SERVICE BULLETIN

SB # 180212-974699-9WE

SUBJECT: Incorrect Nut internal threads causing damage during installation.

Figure 1, Image of Nut-Hex Showing Incorrect Internal Thread

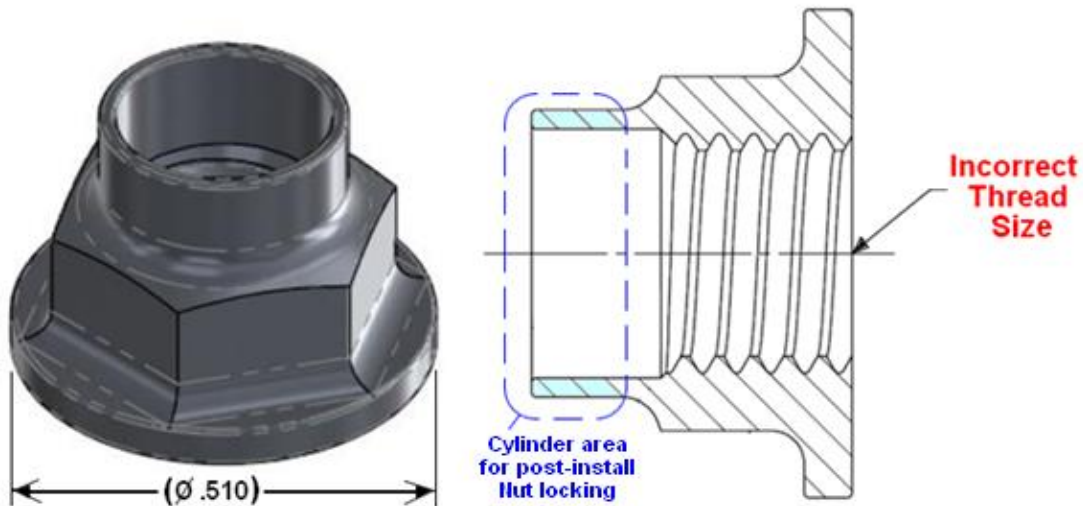
The Nut internal threads were incorrectly designed and manufactured with a threads per inch (TPI) of **.250-32 UNJEF-3B**. The correct threads per inch is **.250-28 UNJF-3B**.

The Nut-Hex is installed into various NHA's and is used as a typical fastener at the end of a shaft in those locations, see one installed example in figure 2 below. The Nut also incorporates an extended cylinder area that is deformed or crimped after being fully installed to ensure the Nut-Hex will not come off the mating shaft, see figure 1 above.

Following the applicable NHA CMM instructions, remove the Wencor Nut-Hex and return the removed Nut-Hex to Wencor. Inspect the mating shaft threads for damage, replace the mating shaft if damaged threads are found. Replace the Nut-Hex with an approved Nut-Hex with the proper threads per inch (.250-28) and properly follow the NHA CMM instructions for assembly.

Figure 2: Example of Nut-Hex Installed into NHA

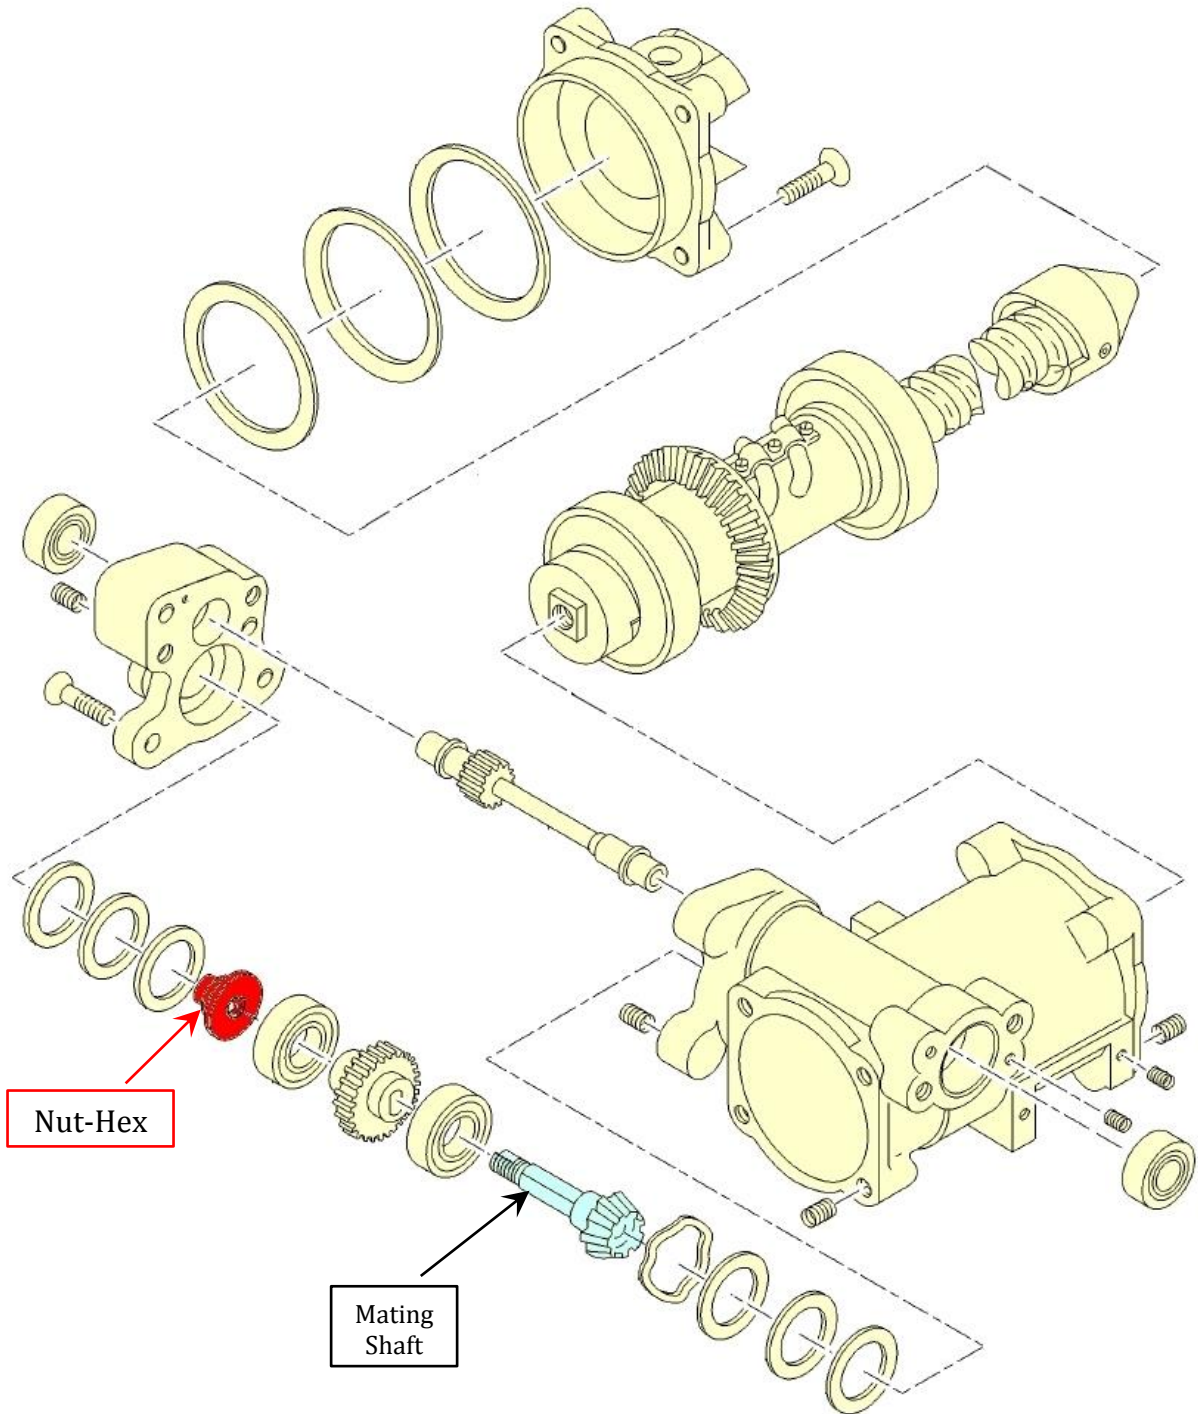
The incorrect Nut-Hex threads per inch (TPI) would prevent proper installation of the Nut onto the mating shaft of the NHA and the Nut would not be able to be fully installed onto the mating shaft without exceeding the required assembly torque value defined in the NHA CMM. However, if excessive force was used to attempt to fully install the Nut, it would cause thread damage to both the Nut and the mating shaft.
